REV.  
C

AS3139™

(R) STUD, STEPPED - 2.5 DIA ENGAGEMENT,  
PD SHANK, UNS S66286  
.2500-28 UNJF-3A X .1900-32 UNJF-3A

FIGURE 1 - STUD

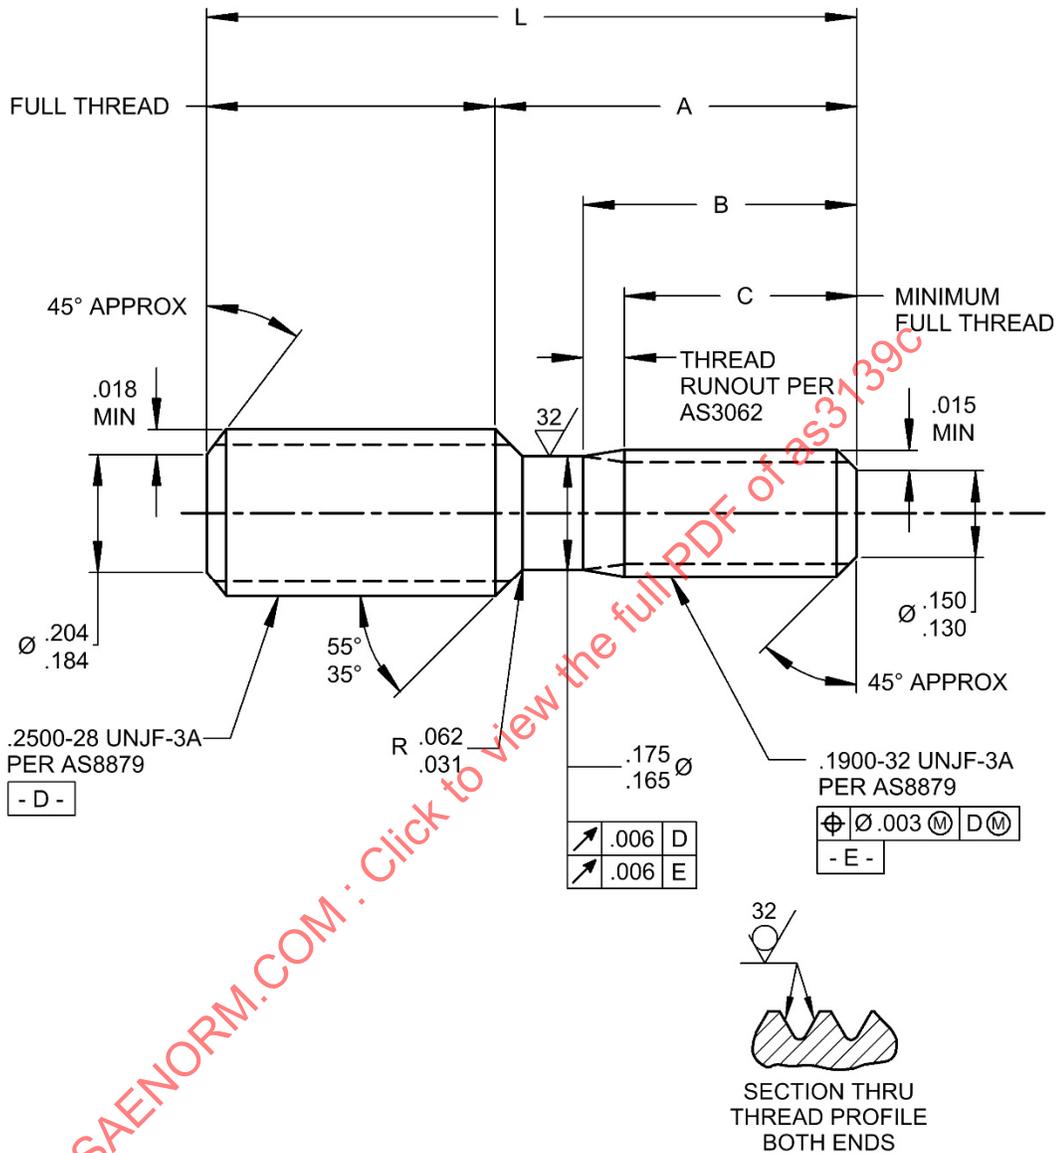
RELOCATE POSITION FEATURE CONTROL FRAME TO THREAD CALLOUT, REVISE LEAD THREAD CHAMFERS TO CONFORM TO AS1132, ADD AS3062 THREAD RUNOUT, ADD NEW NOTE FOR DISPOSITION OF EXISTING INVENTORY, GENERAL EDITORIAL UPDATES.
